APPLICATION FOR SUBMITTAL OF POST-APPROVAL DOCUMENT

1. SUBMITTAL TYPE:	(Is this a resubmittal? Yes 🖌 No)					
Deferred Submittal 🗆	Addendum Number:	Revisi	on Number:	CCD Nu	mber: 003 V2	Category A 🖌 or B

2. PROJECT INFORMA	TION:						
School District/Owner:	San Rafael City Schools				DSA File Numbe	er: 21 H1	
Project Name/School: T	erra Linda HS Shade Structure & En	try Cano	ру		DSA Application	Number 01 120767

1 of 10 RFP 002.1

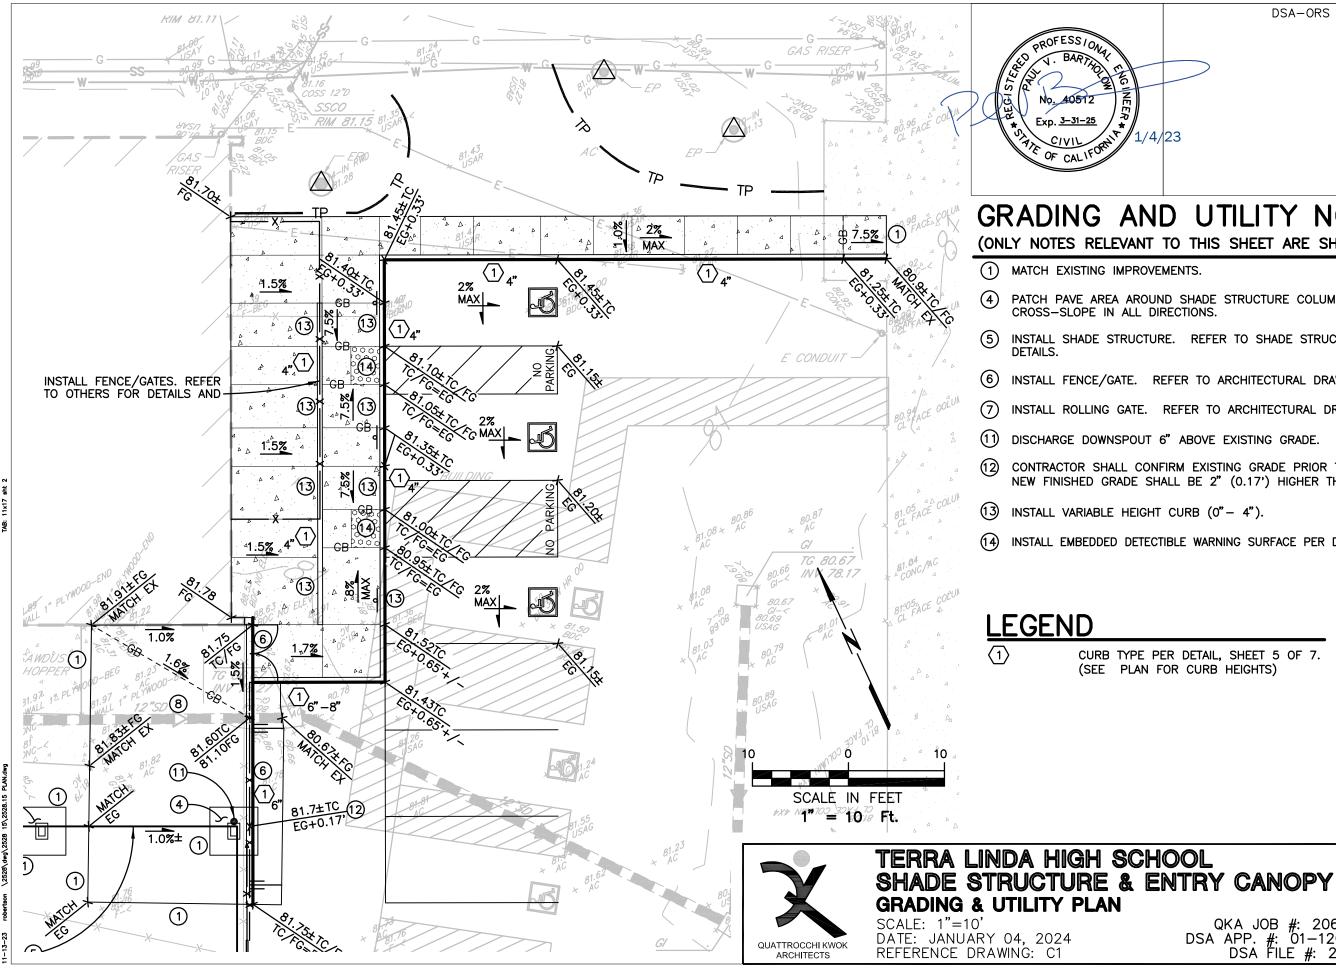
REMOVE ALL EXISTING SURFACE IMPROVEMENTS, INCLUDING, BUT NOT LIMITED TO, ASPHALT AND CONCRETE, CURBS, BASE MATERIAL, RAMPS, ETC WITHIN THE LIMITS OF THE HATCHING IDENTIFIED HEREON AND PROPERLY DISPOSE OF OFFSITE, UNLESS OTHERWISE NOTED. AT THE CONTRACTORS OPTION, NON-CONTAMINATED BASE MATERIAL MAY BE REUSED.

REMOVE ALL VEGETATION, INCLUDING, BUT NOT LIMITED TO GRASS, PLANTS, SHRUBS, ETC, WITHIN THE LIMITS OF THE HATCHING IDENTIFIED HEREON AND PROPERLY DISPOSE OF

DISPOSE OF OFFSITE. REFER TO ARCHITECTURAL DRAWINGS FOR LIMITS OF DEMOLITION, SALVAGE OF EXISTING MATERIALS, AND ADDITIONAL DEMOLITION

3 of 10

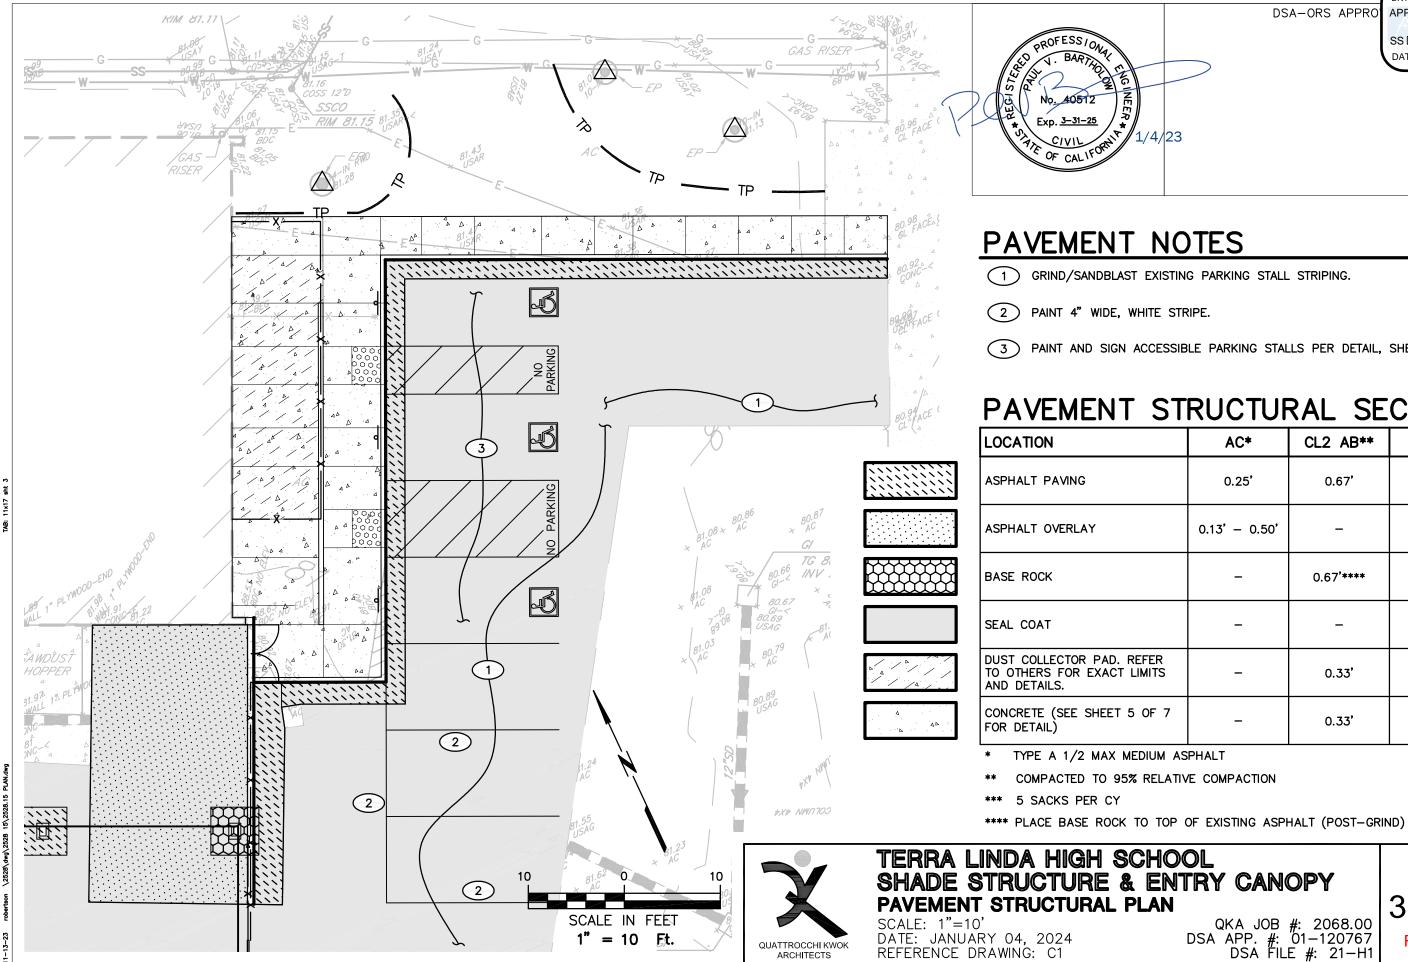
GRIND/SANDBLAST EXISTING PARKING STALL STRIPING.

(3) PAINT AND SIGN ACCESSIBLE PARKING STALLS PER DETAIL, SHEET 6 OF 7.

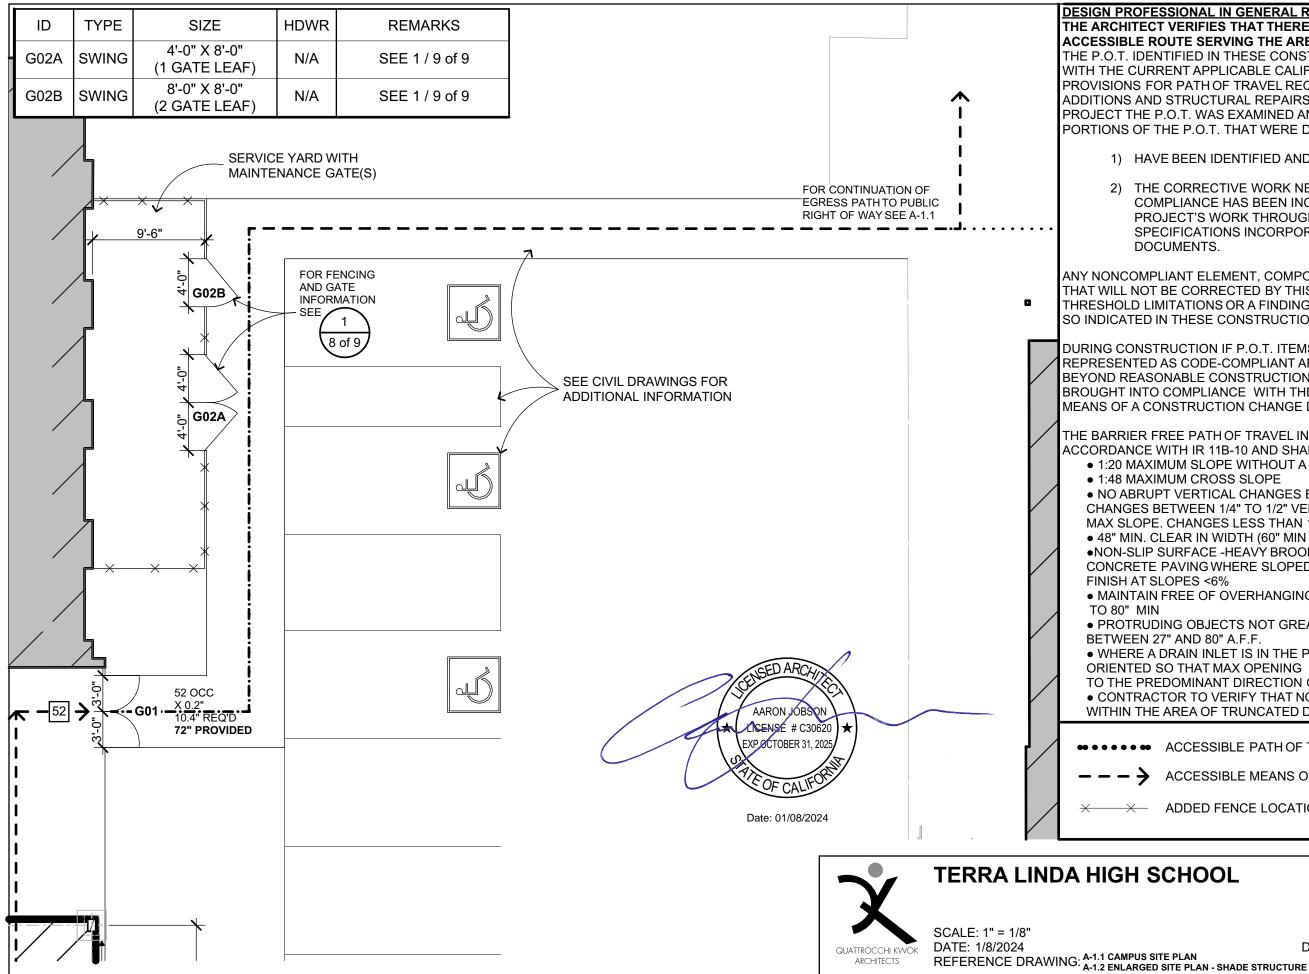
APPROVED DIV. OF THE STATE ARCHITECT DESIGN PROFESSIONAL IN GENERAL RESPONSIBLE CHAR THE ARCHITECT VERIFIES THAT THERE ARE NO BARRIERS APP: 01-120767 INC: REVIEWED FOR ACCESSIBLE ROUTE SERVING THE AREA OF WORK. THE P.O.T. IDENTIFIED IN THESE CONSTRUCTION DOCUME SS FLS ACS DATE: 01/09/2024 WITH THE CURRENT APPLICABLE CALIFORNIA BUILDING CO PROVISIONS FOR PATH OF TRAVEL REQUIREMENTS FOR ALTERATIONS ADDITIONS AND STRUCTURAL REPAIRS. AS PART OF THE DESIGN OF THIS PROJECT THE P.O.T. WAS EXAMINED AND ANY ELEMENT, COMPONENTS OR PORTIONS OF THE P.O.T. THAT WERE DETERMINED TO BE NONCOMPLIANT 1) HAVE BEEN IDENTIFIED AND 2) THE CORRECTIVE WORK NECESSARY TO BRING THEM INTO COMPLIANCE HAS BEEN INCLUDED WITHIN THE SCOPE OF THIS PROJECT'S WORK THROUGH DETAILS, DRAWINGS AND SPECIFICATIONS INCORPORATED INTO THESE CONSTRUCTION DOCUMENTS. ANY NONCOMPLIANT ELEMENT, COMPONENT, OR PORTION OF THE P.O.T. THAT WILL NOT BE CORRECTED BY THIS PROJECT BASED ON VALUATION THRESHOLD LIMITATIONS OR A FINDING OF UNREASONABLE HARDSHIP ARE SO INDICATED IN THESE CONSTRUCTION DOCUMENTS. DURING CONSTRUCTION IF P.O.T. ITEMS WITHIN THE SCOPE OF THE PROJECT REPRESENTED AS CODE-COMPLIANT ARE FOUND TO BE NONCONFORMING BEYOND REASONABLE CONSTRUCTION TOLERANCES, THEY SHALL BE BROUGHT INTO COMPLIANCE WITH THE CBC AS A PART OF THIS PROJECT BY MEANS OF A CONSTRUCTION CHANGE DOUCMENT. THE BARRIER FREE PATH OF TRAVEL INDICATED HAS BEEN PROVIDED IN ACCORDANCE WITH IR 11B-10 AND SHALL COMPLY WITH THE FOLLOWING: • 1:20 MAXIMUM SLOPE WITHOUT A RAMP 1:48 MAXIMUM CROSS SLOPE NO ABRUPT VERTICAL CHANGES EXCEEDING 1/4". CHANGES BETWEEN 1/4" TO 1/2" VERTICAL CAN BE AT 1:2 MAX SLOPE. CHANGES LESS THAN 1/4" CAN BE VERTICAL • 48" MIN. CLEAR IN WIDTH (60" MIN PASSING SPACE) NON-SLIP SURFACE -HEAVY BROOM FINISH AT EXTERIOR CONCRETE PAVING WHERE SLOPED >6%. MEDIUM BROOM MAINTAIN FREE OF OVERHANGING OBSTRUCTIONS • PROTRUDING OBJECTS NOT GREATER THAN 4" SHALL BE MOUNTED BETWEEN 27" AND 80" A.F.F. • WHERE A DRAIN INLET IS IN THE PATH OF TRAVEL, THE GRATE SHALL BE ORIENTED SO THAT MAX OPENING IS 1/2" & LONG DIM IS PERPENDICULAR TO THE PREDOMINANT DIRECTION OF PEDESTRIAN TRAVEL CONTRACTOR TO VERIFY THAT NO BELOW-GRADE PULL BOXES OCCUR WITHIN THE AREA OF TRUNCATED DOMES ACCESSIBLE PATH OF TRAVEL ACCESSIBLE MEANS OF EGRESS ADDED FENCE LOCATION 9 of 10 QKA JOB #:2068.00 DSA APP. #:01-120767 RFP 002.1 DSA FILE #:21-H1
